Re: **Errata to Township of Bonnechere Valley Environmental Screening Report
Ruby Road Waste Disposal Site Expansion
Cambium Ref. No.: 07-1219-001**

Errata to Appendix J
Correspondence with the Ministry of the Environment

**Re: Responses to MOE Comments in 2011 dated July 28, October 18, and November 15
Environmental Screening of Capacity Expansion at Ruby Road Waste Disposal Site
Cambium Reference: 1219-001**

GROUNDWATER ELEVATIONS

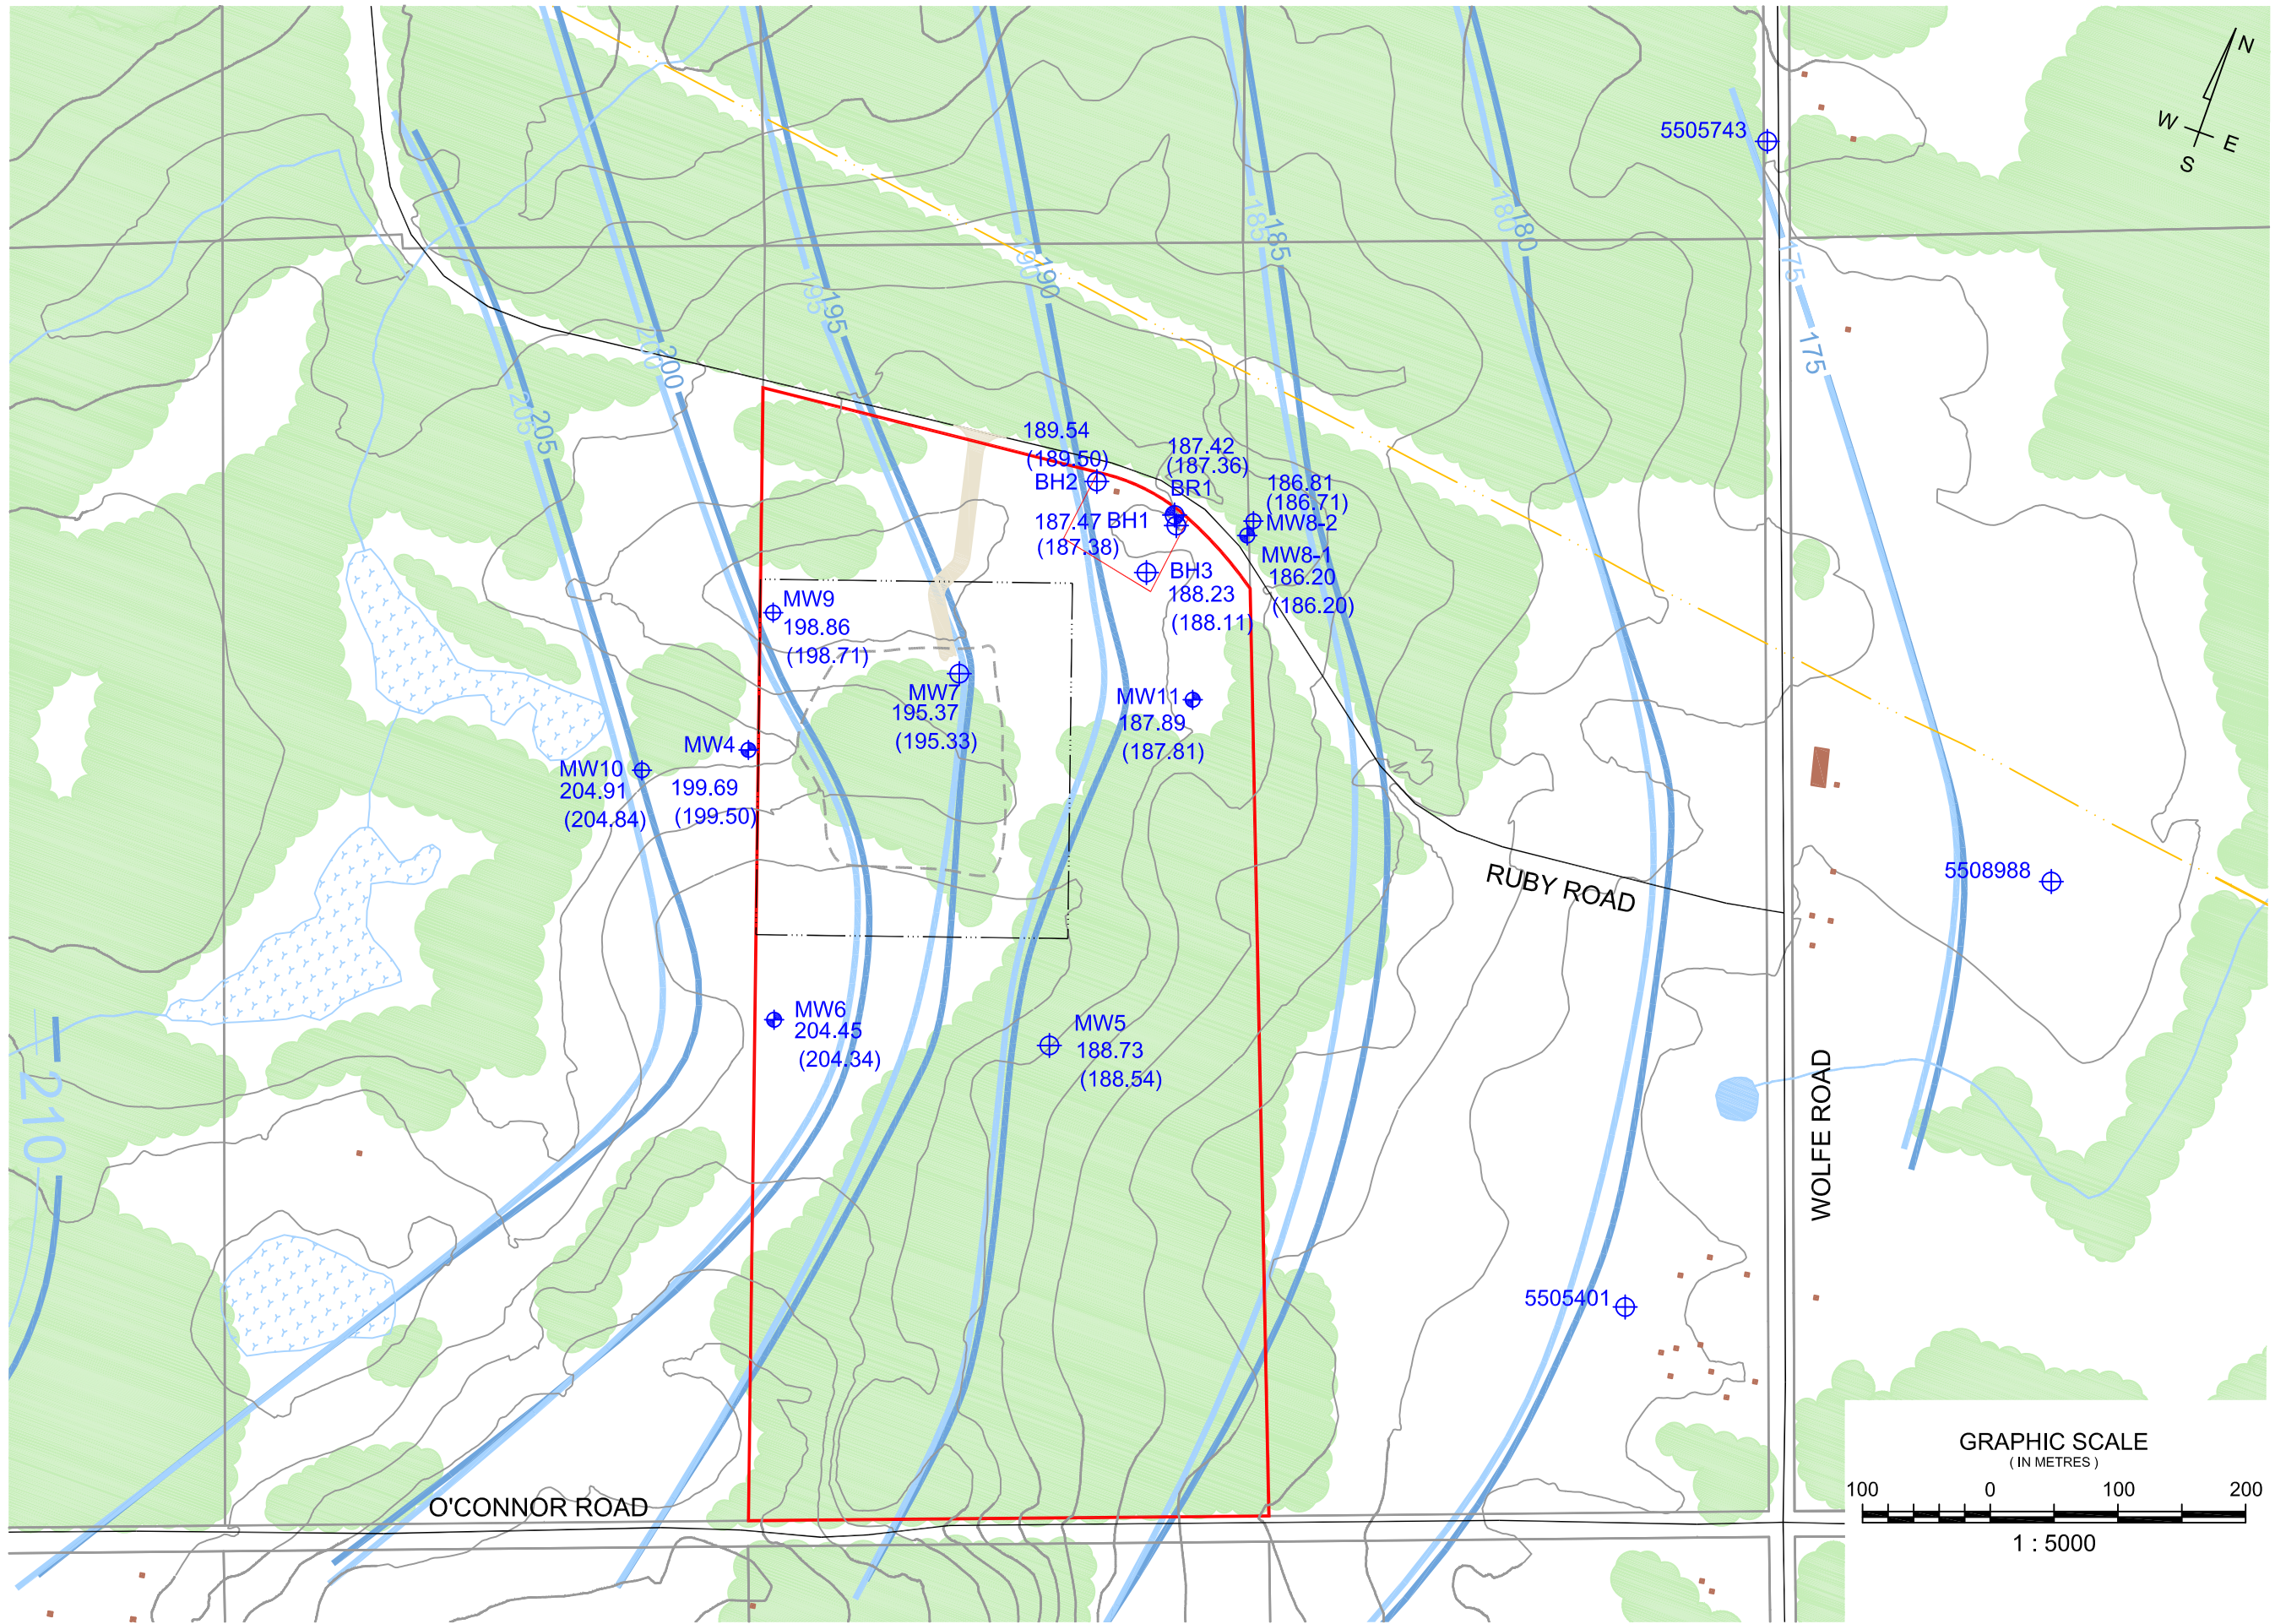
Cambium Environmental Inc. (Cambium), on behalf of the Township of Bonnechere Valley (Township), has prepared the following response to your correspondence dated October 10, 2012, which recommended an additional round of groundwater level measurements to confirm the water levels measured at the newly installed monitoring wells and to confirm the overall conceptual model.

Water levels were obtained from the Site, from all existing monitoring wells (i.e. BH1 through MW11) on October 16, 2012. An updated table of water elevations and figures with groundwater elevations and groundwater flow have been attached for your records. The groundwater elevations obtained in October were similar to those observed in July and have confirmed the conceptual model for the Site. Based on the attached, Cambium and the Township will await formal comment from the Ministry of the Environment (MOE) prior to finalizing the Environmental Screening Report for submission.

Figure 2 Updated Depiction of Predicted Leachate Plume

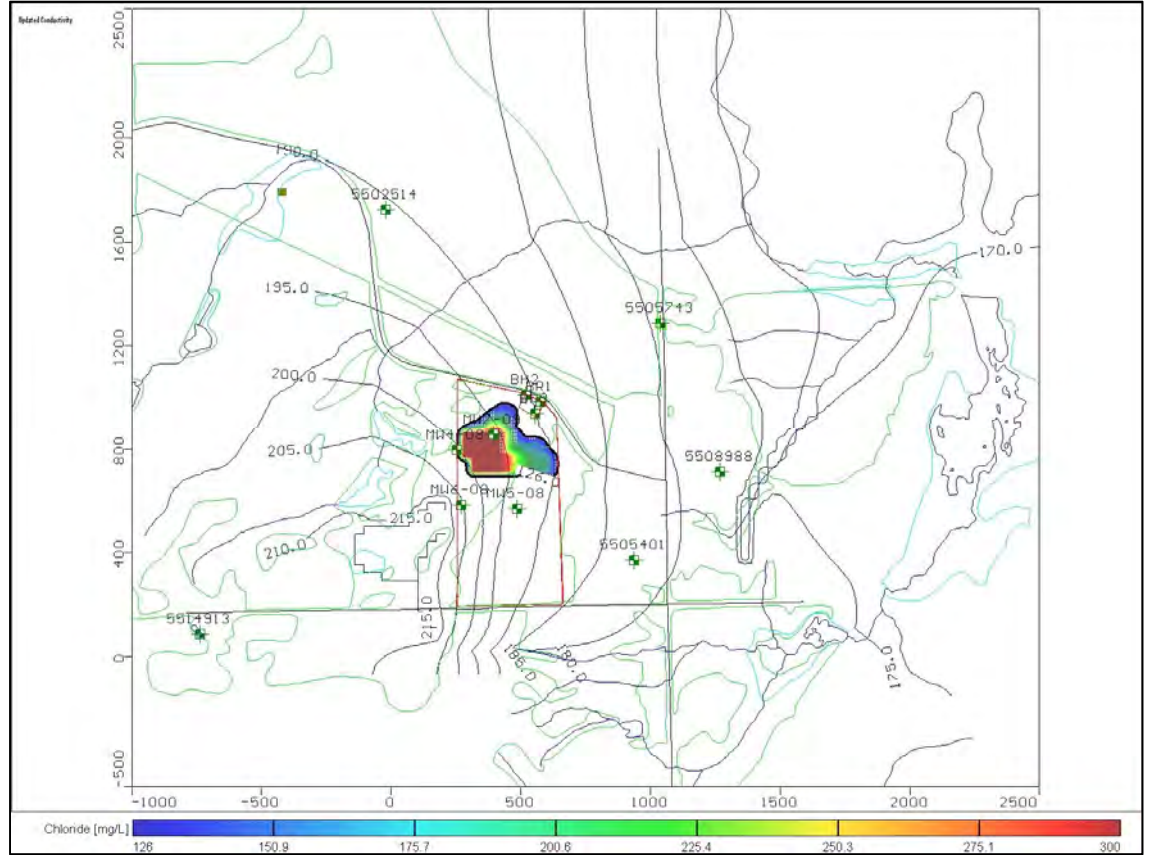
The TSS groundwater reviewer has expressed doubt regarding the extent of the leachate plume migration predicted by the hydrogeological modeling as prepared by Cambium to determine the groundwater impact of the proposed capacity expansion at the Ruby Road WDS. These doubts are based on concerns over the representative and predictive accuracy of the hydrogeological model specifically due to: a discrepancy in the hydraulic conductivity value used at groundwater monitoring point MW4-08 in the model, the groundwater recharge values used in the model, and the representation of the overburden and bedrock characteristics downgradient of the proposed waste disposal area expansion in the model.

In recognition of the reviewer's concerns, Cambium updated the hydrogeological model to the measured hydraulic conductivity value of 4.84×10^{-6} m/s instead of the value of 4.84×10^{-7} m/s that had been inappropriately applied to MW4-08. The values used in the model are intended to reflect actual field measured values whenever they are available, as is the case with this correction. The concern of the reviewer that the correction of the hydraulic conductivity value at

MW4-08 would have profound implications for the model were not validated by the fact that the resultant leachate plume extent prediction did not change significantly and the calibration of the model overall remained acceptable as shown below in Figure 2 and Figure 3.
